Application No.: 10/640,349

Docket No.: JCLA11051

Application No.: 10/640,349**Docket No.: JCLA11051****REMARKS**

FIG. 1 (PRIOR ART)

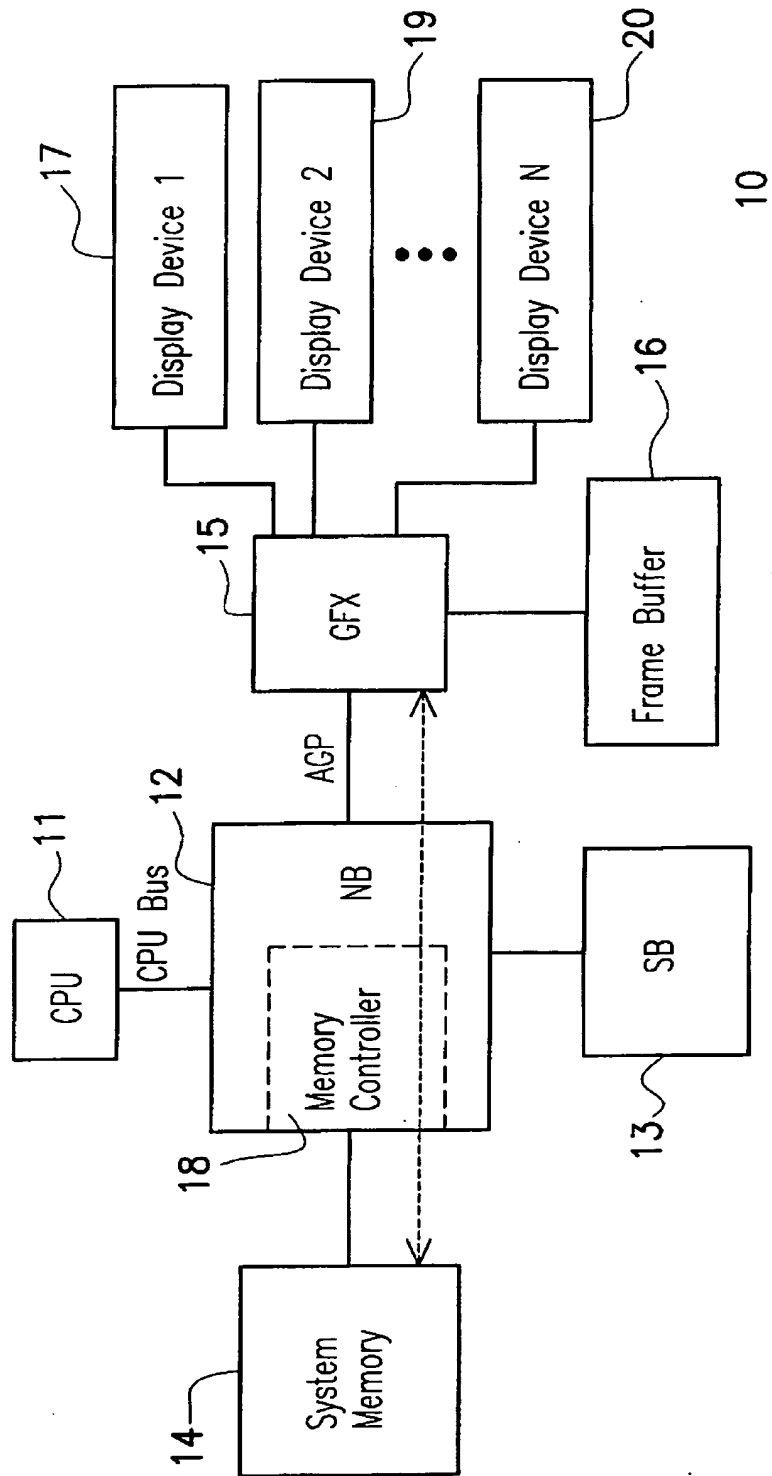
Please amend the drawings by replacing the original filed drawing sheets with the attached clear version of corrected drawing sheets, in which "prior art" marks are appropriately marked in FIGS. 1- 3, as they should be.

Annotated Marked-up drawing

FIG. 2 (PRIOR ART)

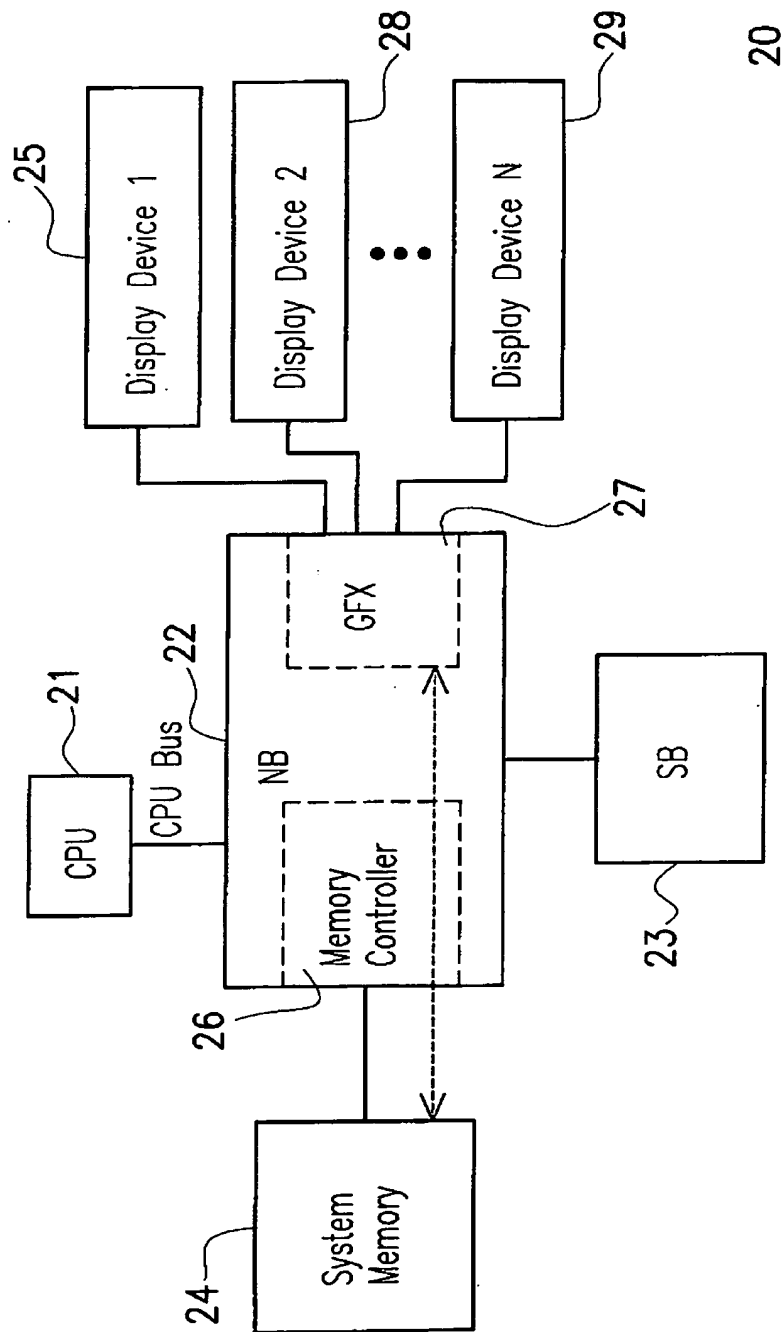
Annotated Marked-up drawing

FIG. 3 (PRIOR ART)

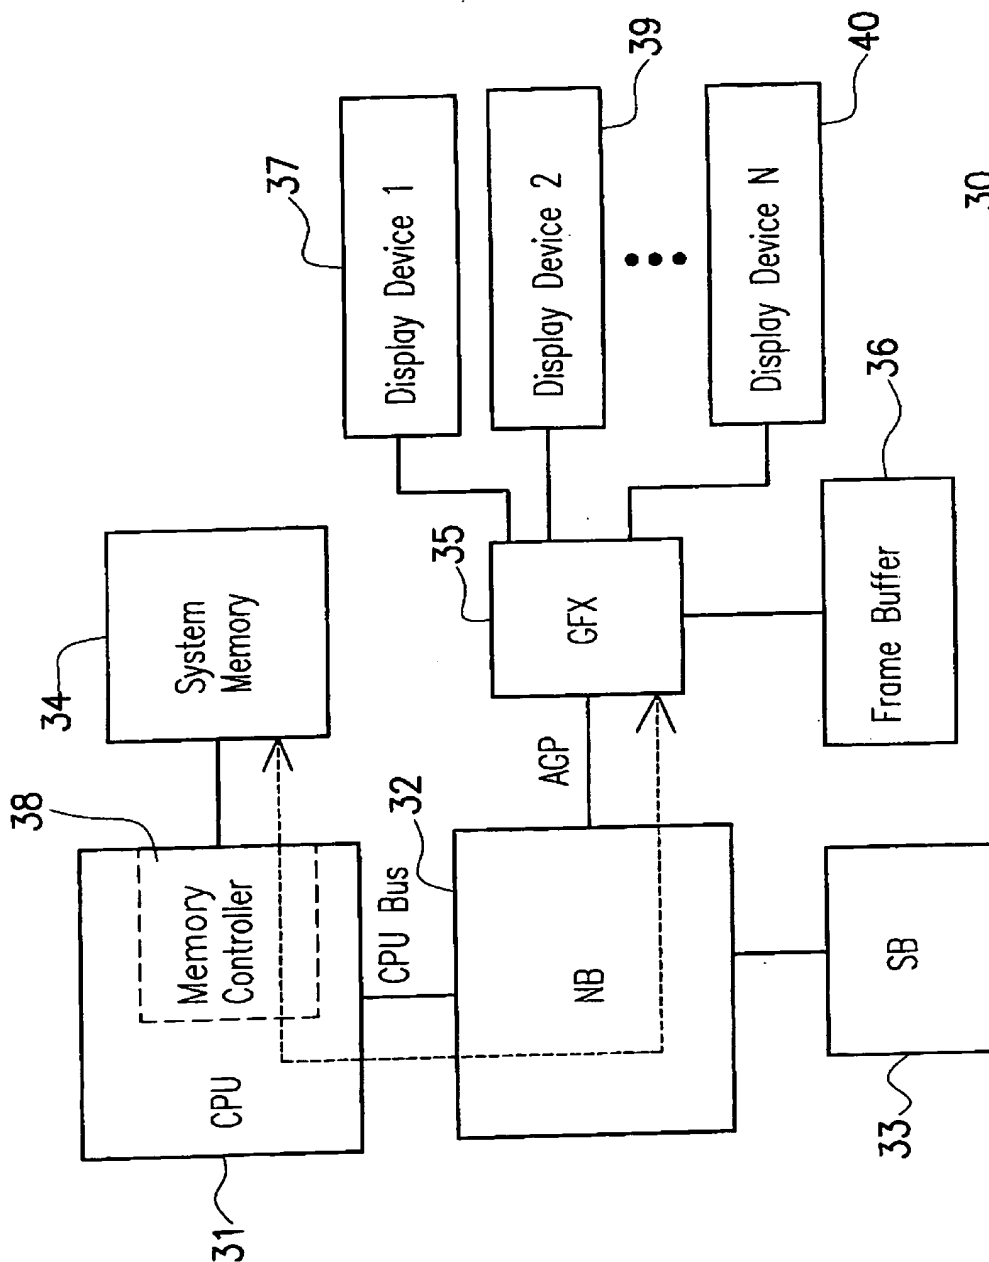
Annotated Marked-up drawing
